**HERITAGE VAUGHAN COMMITTEE    JANUARY 21, 2015**

**3.    HERITAGE REVIEW OF PROPOSED NEW CONSTRUCTION AT 124, 112-116 WOODBRIDGE AVENUE AND CONSERVATION OF THE GILMOUR HALLETT HOUSE - WARD 2**

3D coloured rendering views – south portion of proposed building, bird's eye view of podium terrace.

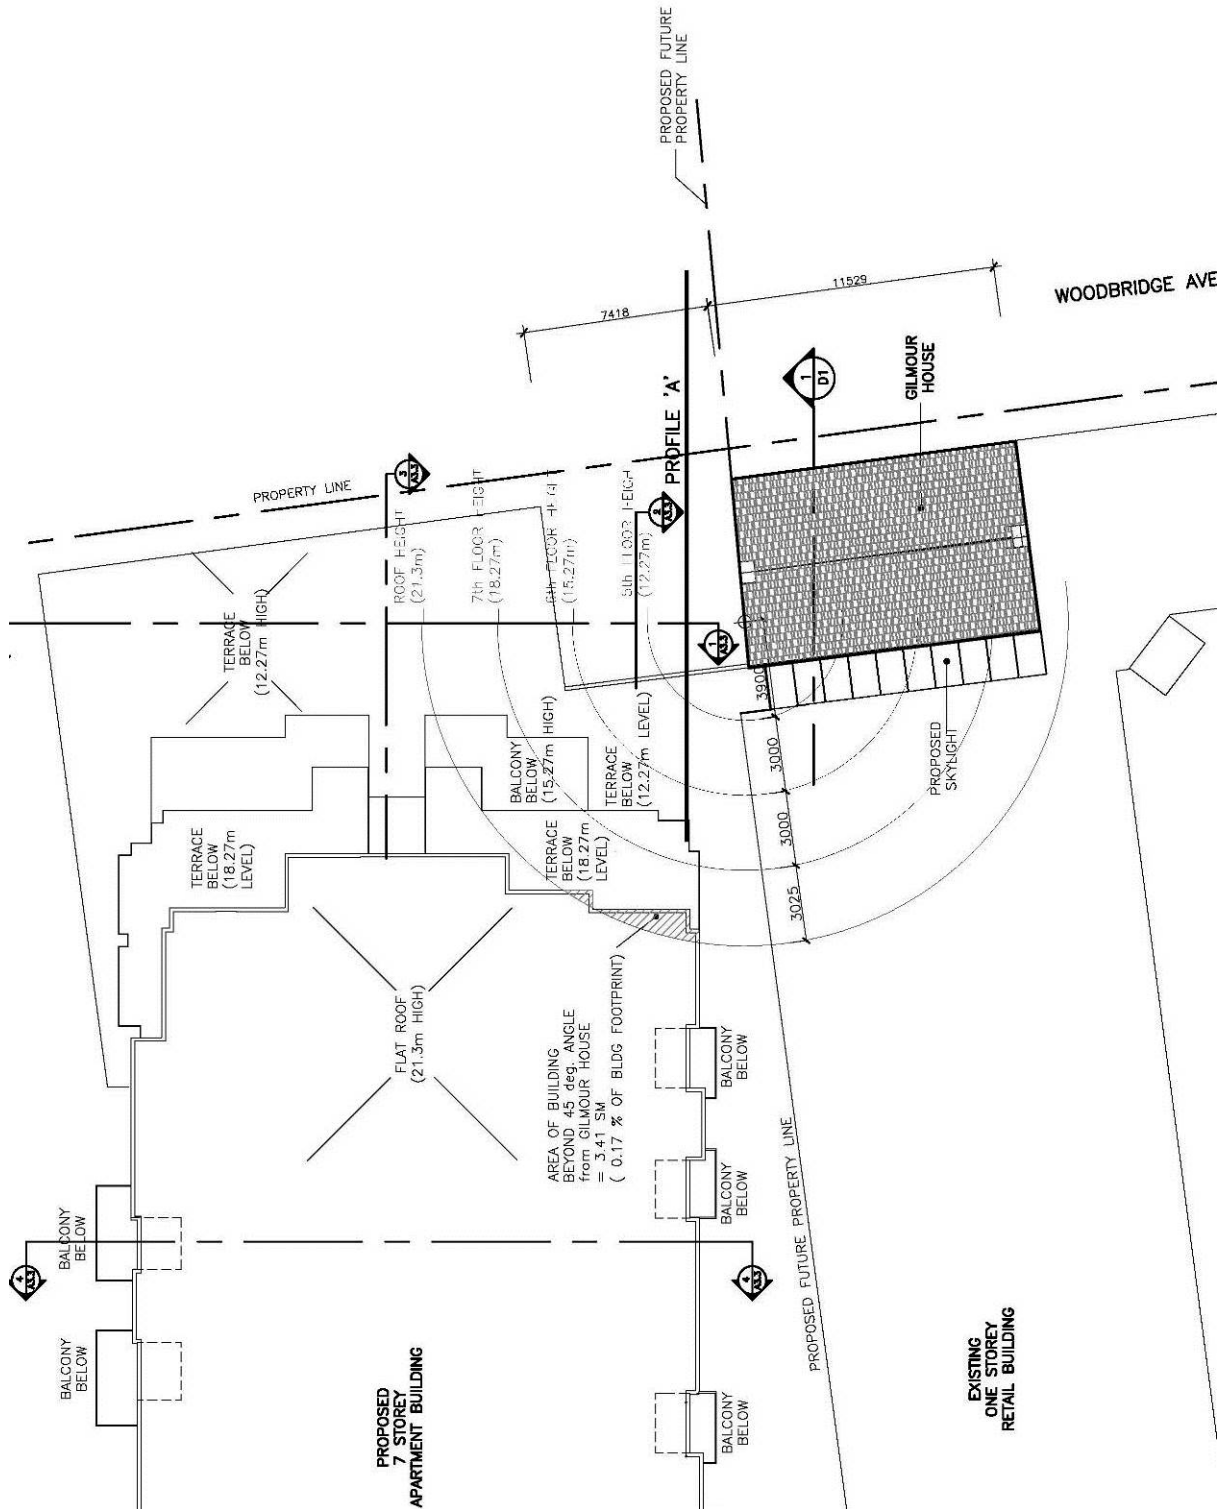
- c) The required 45 degree building step back from the height of the adjacent Gilmour Hallett house is not met. The area of the proposed building beyond the 45 degree angle from the Gilmour House is 3.41 square metres (See Attachment #9). The Heritage Vaughan Committee may consider this a relatively marginal amount and that there would be no undue impact to the adjacent heritage resource. Additionally, the upper stories of the proposed building are generously set back. This provides the opportunity for a fifth storey terrace, creating a contributing and attractive use for the podium roof (See Attachment #7).

Gilmour house conservation plan drawings.

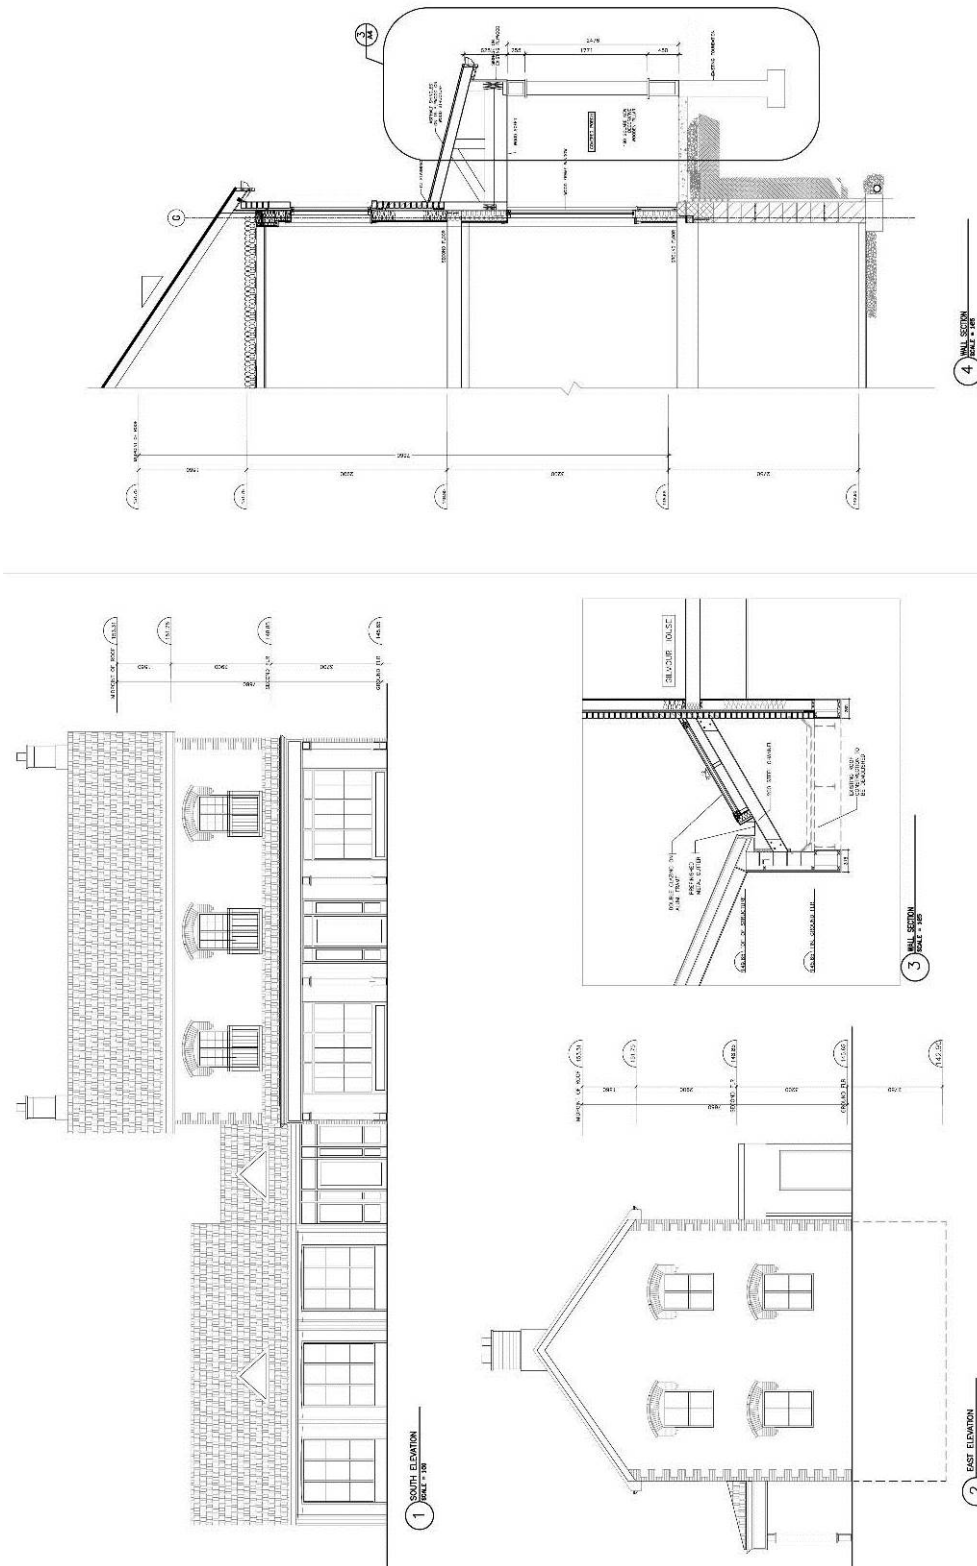
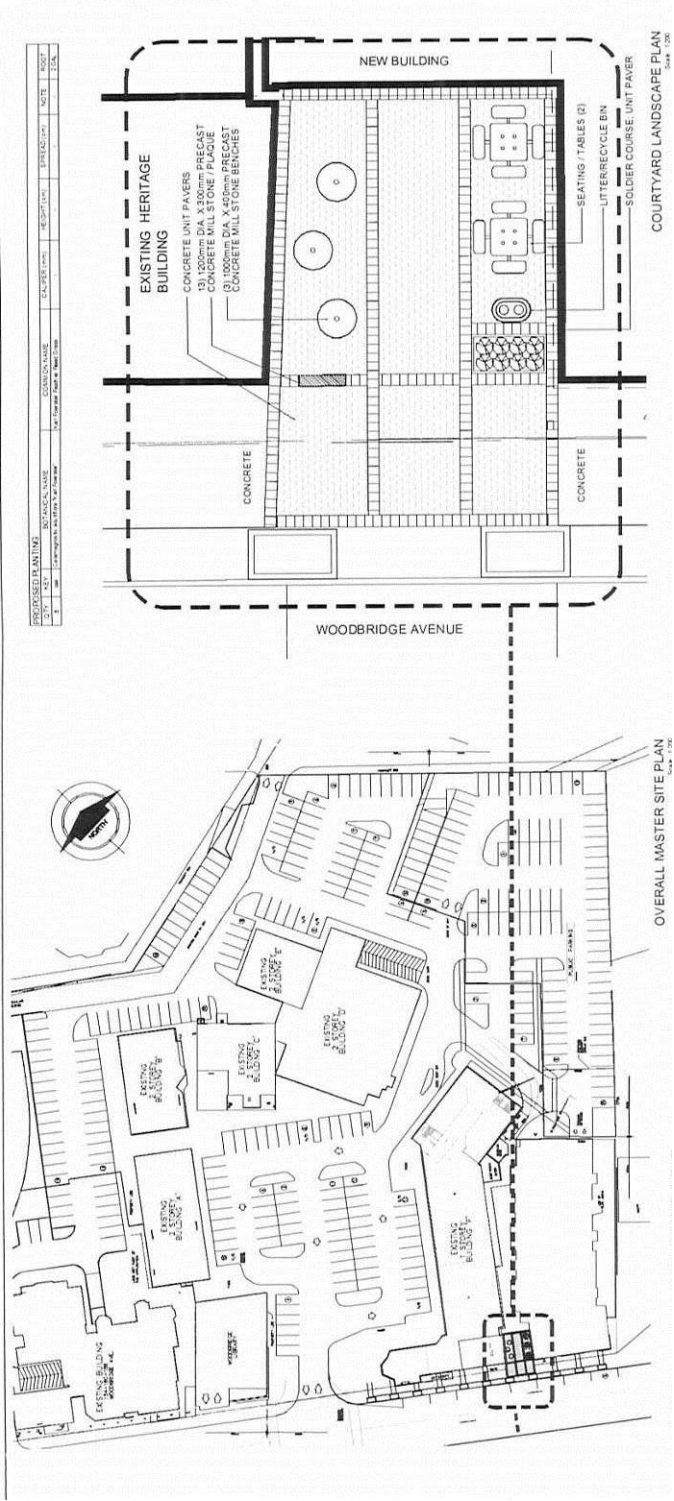
Staff finds that the proposed design for the front porch follows an understated, sympathetic design incorporating square wood columns with a paneled base and capital. A detailed architectural drawing of the paneling will be required for review and approval as well as material specifications and paint colours pertaining to all elements of the porch.

While the Conservation Plan drawings show a skylight introduced in the rear connection, there is no opening in the east wall of the existing commercial building to provide pedestrian access to the new building. Section 3.2 of the study states: “*Skylight: The gap between the north wall of the Gilmour House and the west wing of the Market Square Shopping Centre will be covered by a shed roof skylight, sloping away from the heritage building. This will form a pedestrian link between the new building and the shopping centre. It will not be visible from the exterior, and does not have any negative effect on the heritage character of the Gilmour House.*” Cultural Heritage supports the introduction of an opening in the east wall. This east wall is not part of the original construction of the Gilmour house, but rather part of the 1980’s one storey extension. Staff concurs with the description in the consultant’s report and recommends that the architectural drawings show an accessible, ground floor pedestrian connection from the new building, through the proposed skylight connection to the Market Lane Plaza.

The study did not include photographs with in detail condition assessment of the areas being affected by the proposed interventions named above. This is a City of Vaughan standard requirement for Conservation Plans. It is recommended that the Conservation Plan for the Gilmour Hallett house by an experienced heritage consultant provide an analysis with photographs of the condition of the existing building as it pertains to the areas affected by the proposed work (in particular the skylight and front porch), and that the architectural drawings clearly indicating any existing construction portions to be removed, added and repaired indicating specific methodology.

1.    An analysis with photographs of the condition of the existing building as it pertains to the areas affected by the proposed work (in particular the skylight and front porch);

2.    Architectural drawings clearly indicating any existing construction portions to be removed, added and repaired indicating specific methodology;

3.    Detailed architectural drawings of the paneling of the porch columns, and sign band as well as material specifications and paint colours pertaining to all elements of the porch; and,
